ADDENDUM NUMBER ONE

November 17, 2020

2020 Fox Hollow Health Rm Renovation Eugene School District 4J CIP # 410.187.002

2. Sheet A3.1, Floor Plan:

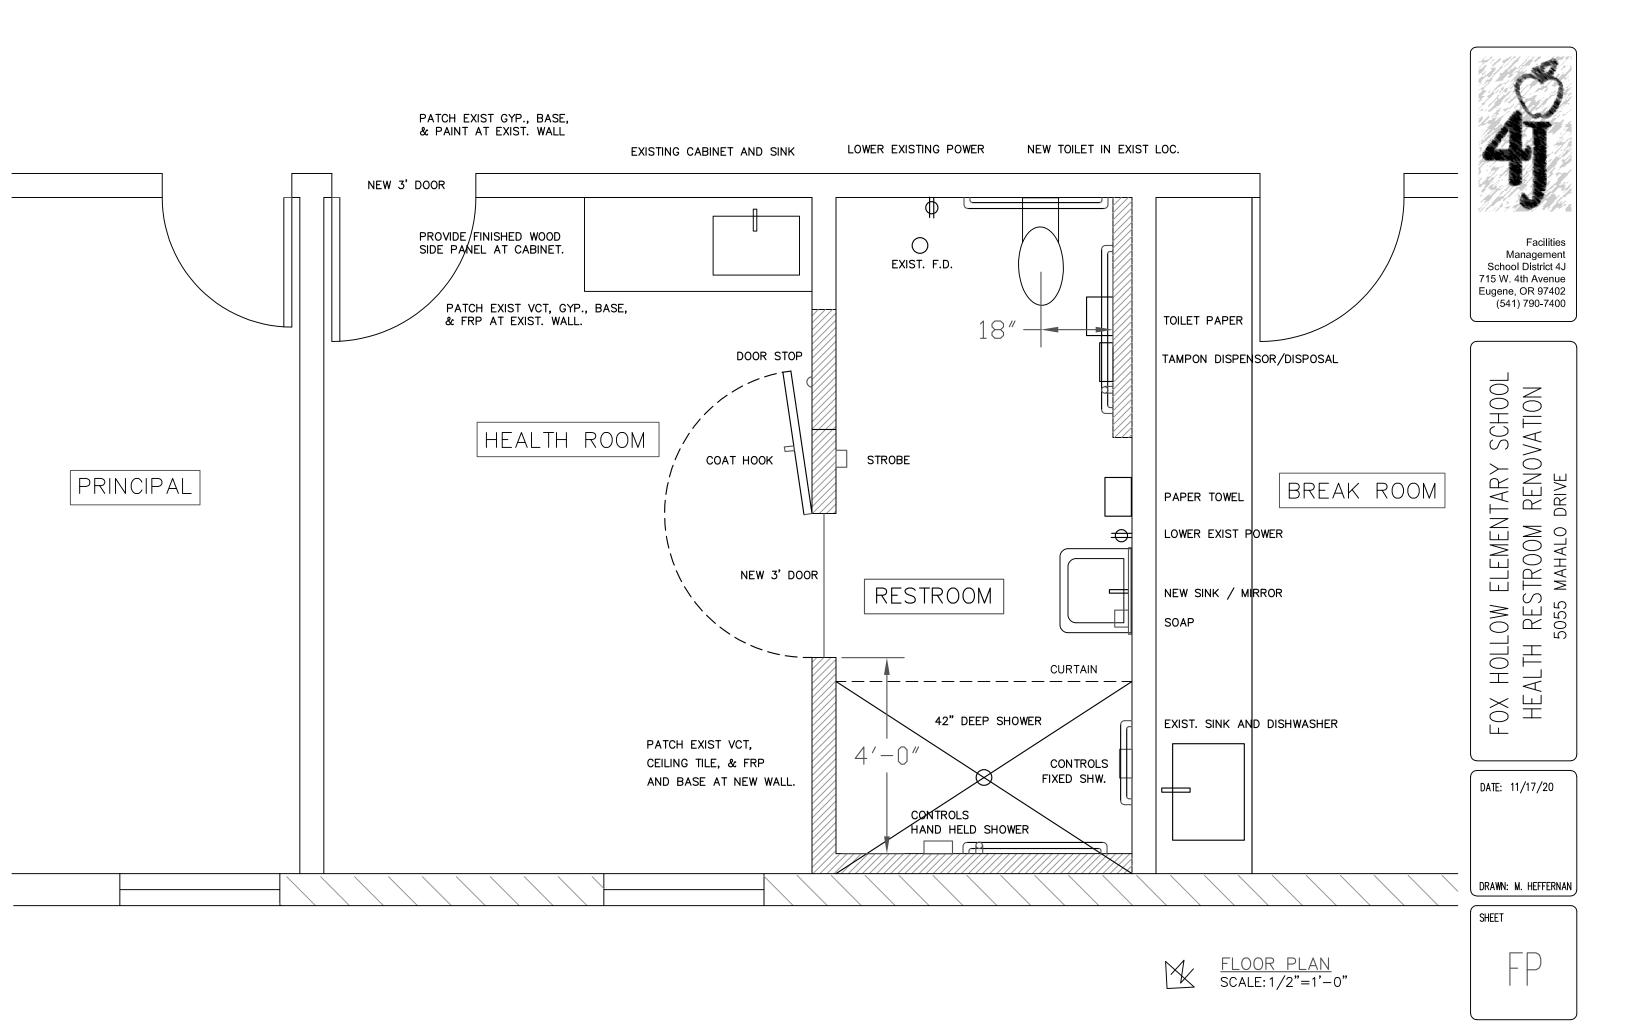
A. Reference the 4J revised Floor Plan layout. Note that the restroom door location has moved. (There is also an existing floor drain next to the toilet that will remain.)

- B. All new walls shown shall be 2x4 wood stud construction to match existing.
- C. A portion of full ht. furred wall also needs to be added in order to reduce the distance from the wall to the toilet to be code.
- D. The unfinished side of the existing cabinet is to get covered with a new finished wood panel to match the cabinet.

3. Sheet A3.1, Reflected Ceiling Plan:

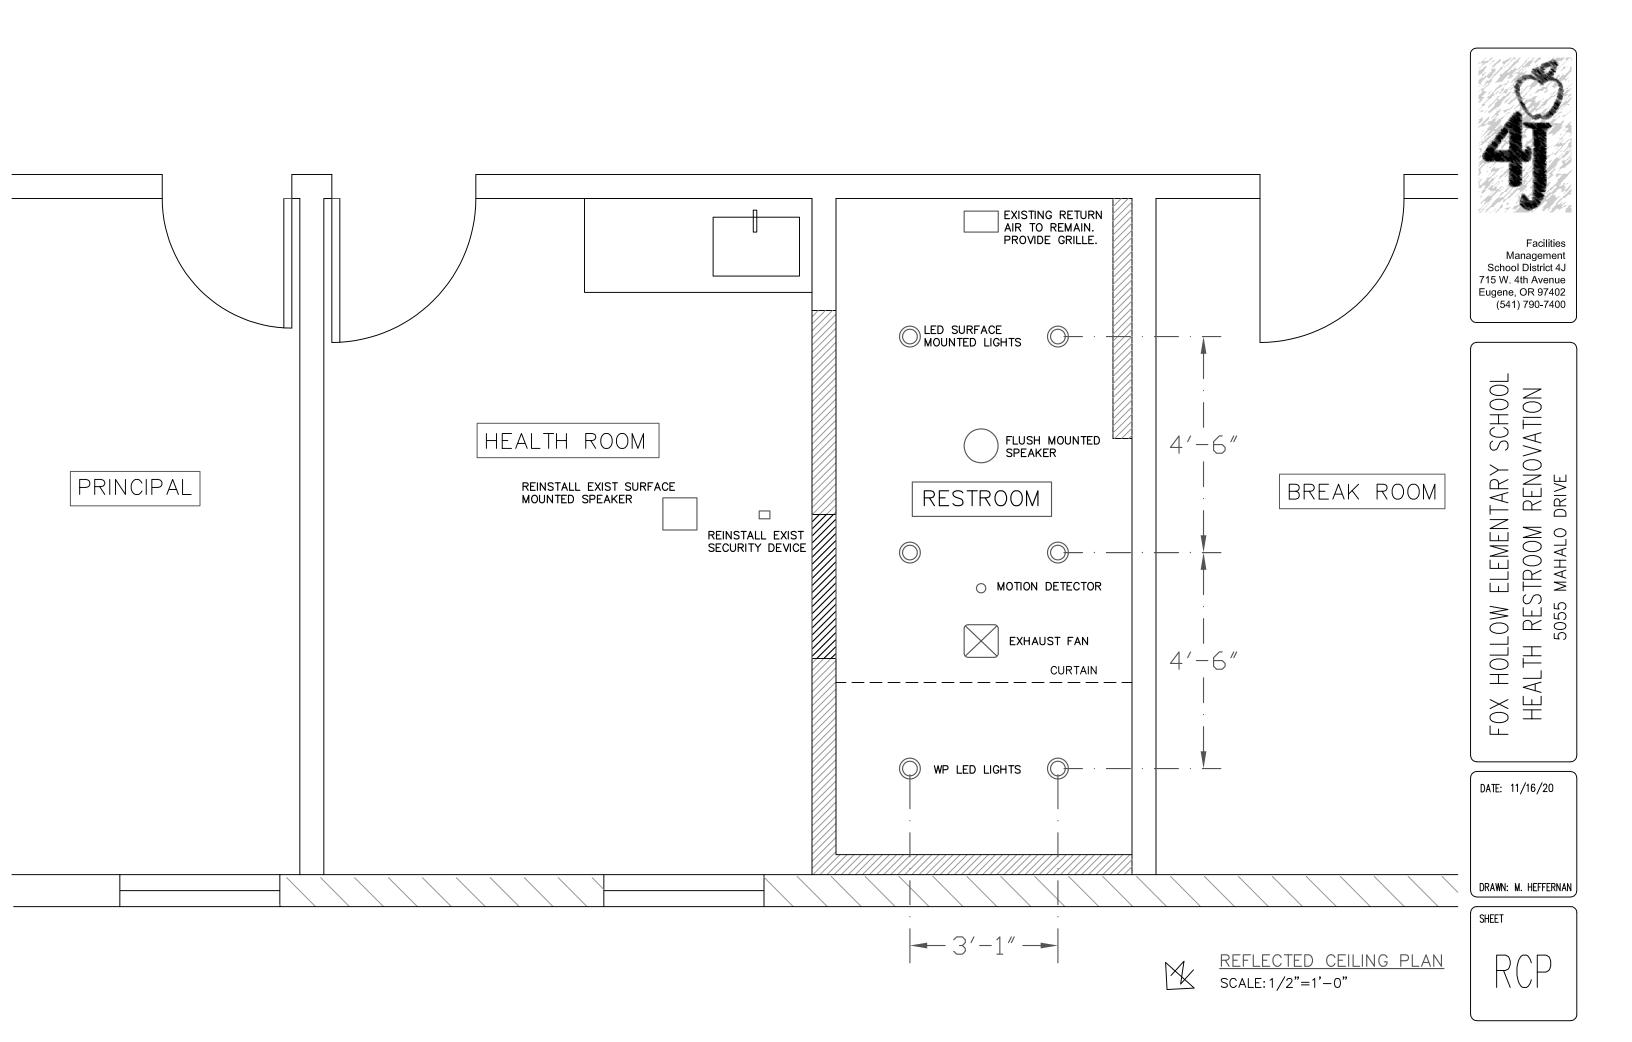
A. Reference the 4J revised Ceiling layout. Note that it shows 2 waterproof LED 6" canless fixtures in the shower and 4 regular LED fixtures in the restroom. Lithonia ultra-thin or equal. The exhaust fan shall be Panasonic or equal installed on a curb up on the Built-up roof.
